## **AGENDA REPORT**

MEETING DATE: JANUARY 28, 2008

**SUBJECT: PLANNING APPLICATION PA-07-31 AND TRACT MAP T-17248 FOR A 7-UNIT RESIDENTIAL COMMON-INTEREST DEVELOPMENT AT 616 CENTER ST. AND 613 PLUMER ST.**

# SUNLIGHT/SHADE STUDY

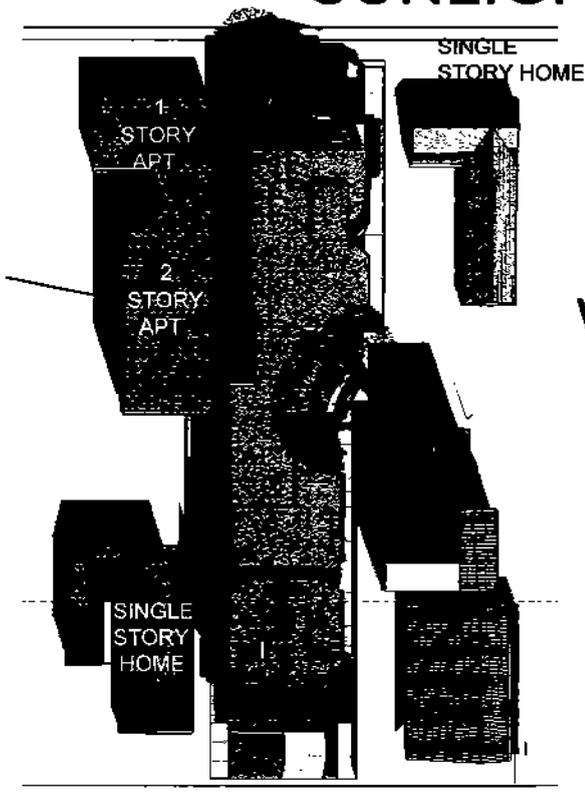
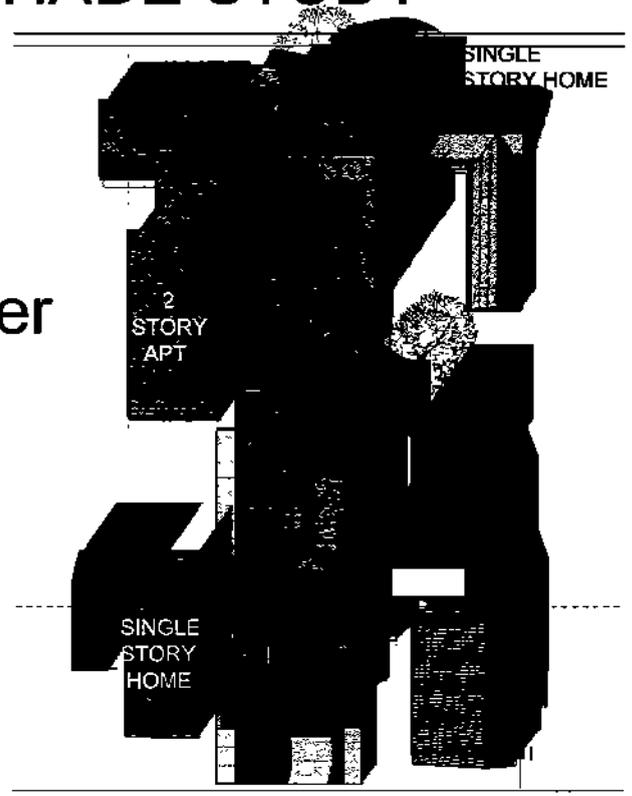
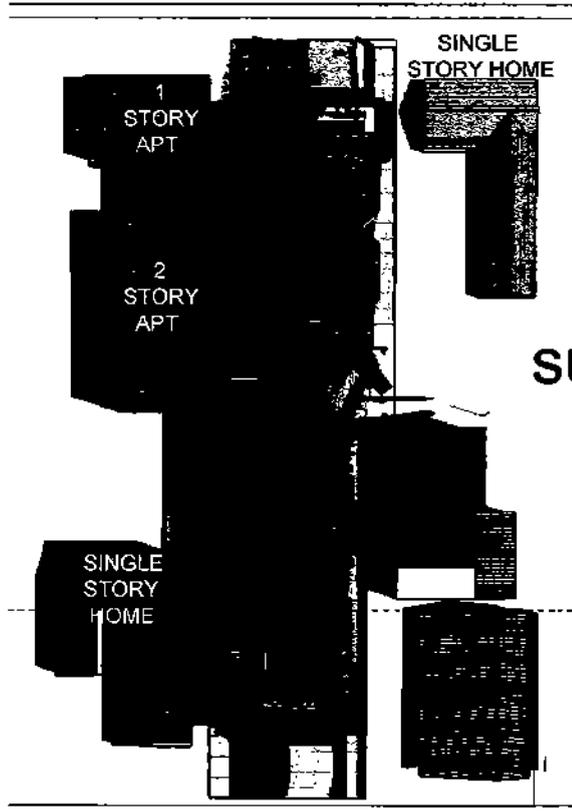
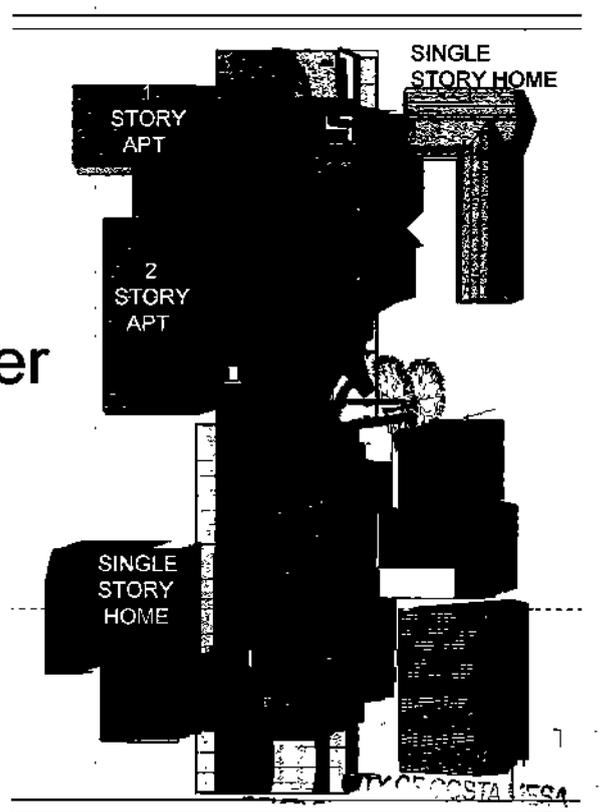
- Three-story building height is analyzed in shade/shadow analysis. The Residential Ownership Urban Plan allows additional height limit of up to three stories/45 feet in the overlay zone. The structure is currently proposed at the maximum height limit. The residential design guidelines indicate that consideration be given to the effect of proposed development on the light, air, and privacy of adjacent properties. As a three-story structure, shade/shadow effects will primarily occur on the neighboring property to the north/northeast in the wintertime. Minimal to no shade/shadow effects will occur during the rest of the year (summer, fall, spring). Given that these shade/shadow effects would still occur with a two-story structure, although the length of shadows would be comparatively shorter, these impacts are not considered significant. Furthermore, since the Urban Plan area has been identified as a revitalization area, this new type of three-story, "urban village"

concept is considered consistent with the plan vision. (Shade/Shadow Simulations, Attachment 6).

3. Prior to submission of building plans for plancheck, developer shall modify the plans to lower the total building height to less than 45 feet, inclusive of the height of the proposed parapet wall.
